**RESPONSE FROM WILLIAM NG CONSULTANTS PTE LTD RECEIVED
ON 14 APRIL 2005**

Feedback on IDA Guideline for Telephone/SCV Room Size

Proposed Telecom Room Layout

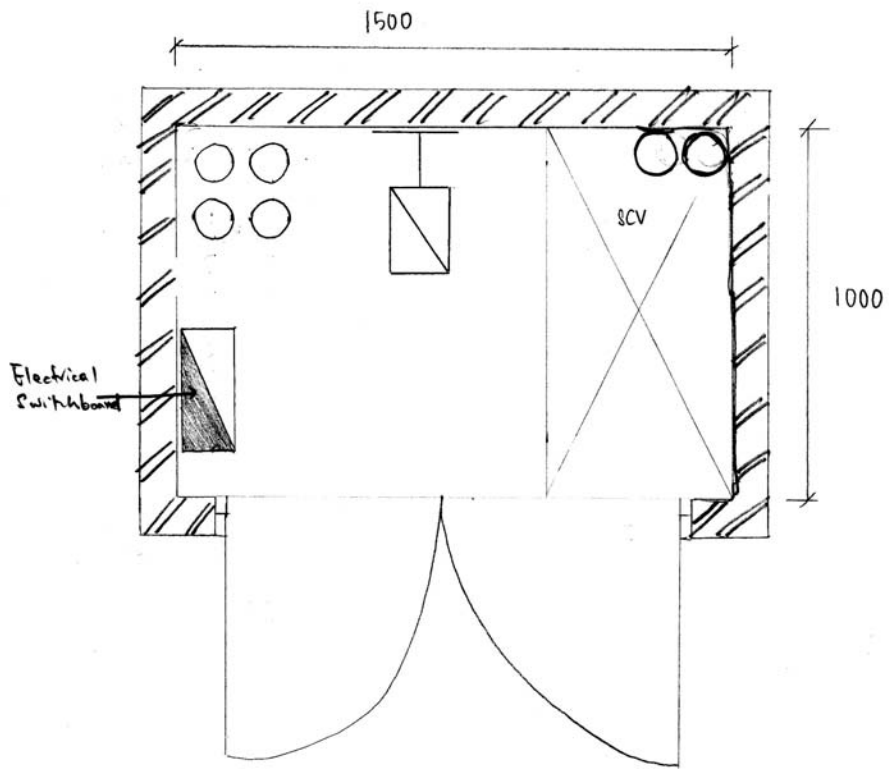
We request that you give special consideration to the small development by reducing the room size of the intake point eg. by installing the telephone equipment at a bigger development nearby instead of imposing larger room for a small development.

<u>Combine services (tel&scv) space</u>
1. Below 10 units attached)	1500 x 1000 mm (Drawing
2. 11 to 20 units	2000 x 2000mm
3. The rest to follow your recommendation.
